# Morecambe Offshore Windfarm: Generation Assets Examination Documents

## Volume 9 VHF, UHF, and DF Technical Safeguarding Assessment

Document Reference: 9.66  
Rev 02

## Appendix B – Stand-Alone versus Multi-Turbine Analysis

Figure B-1 –Combined vs Individual Interference Modelling at 500ft

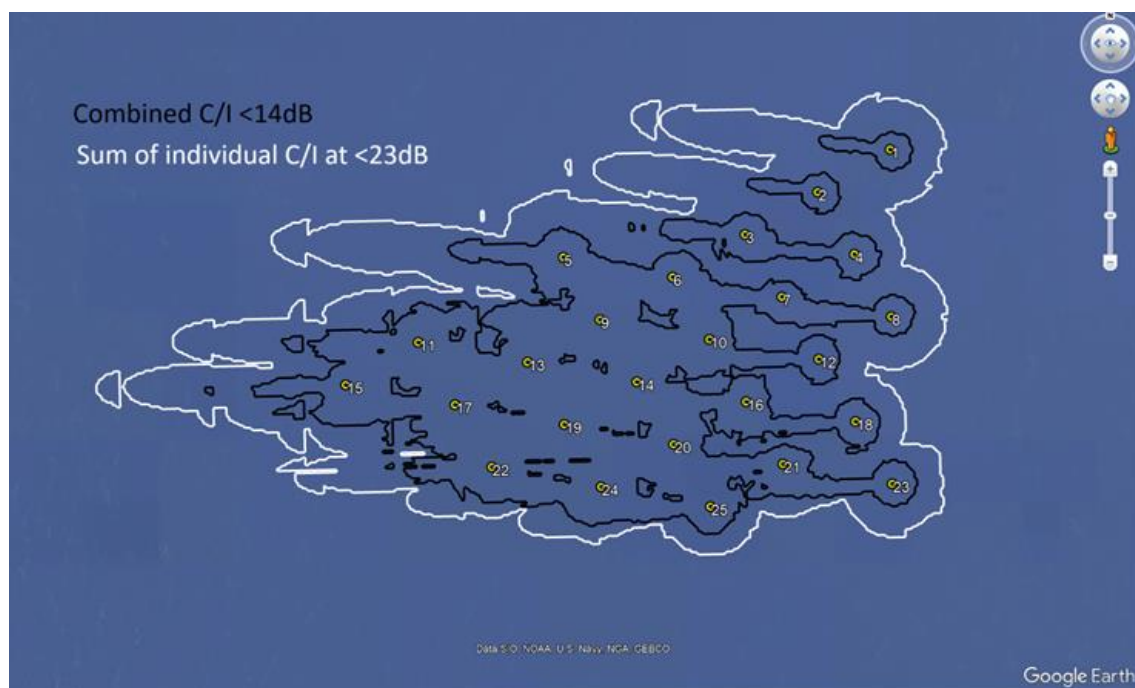
Following the release of Issue 1 of this report the focus on the analysis of each turbine as a stand-alone AGA interference source was questioned. The rationale behind the question is that CAP-670 suggests that both of the following cases should be considered:

- The worst single turbine - Acceptance criteria =  $> 23\text{dB}$  C/I ratio
- All turbine interferers added - Acceptance criteria =  $> 14\text{dB}$  C/I ratio

*CAP670 calls for single turbine checks at  $<23\text{dB}$  as well as a combined turbine check at  $<14\text{dB}$ .*

*Modelling every turbine at every altitude for every radio would have been very computationally intensive and would have added weeks of delay to the delivery of the results based on what remains a representative, rather than definitive set of turbine locations.*

*This however was not the only reason that I skipped over the combined turbine analysis in favour of treating each turbine as a stand-alone “worst single turbine interferer” at  $<23\text{dB}$ ; It is the case for turbine as far apart as these that the individual impact dominates (see below the 500ft, 1,000ft and 1,500ft cases showing this and that the trend gets more pronounced as altitude increases) and therefore it is erring on the side of caution when checking 169 turbines against 12 different radio stations to assume each turbine has their own volume of interference based on the worst case CAP670 criteria and select a few representative samples for analysis.*
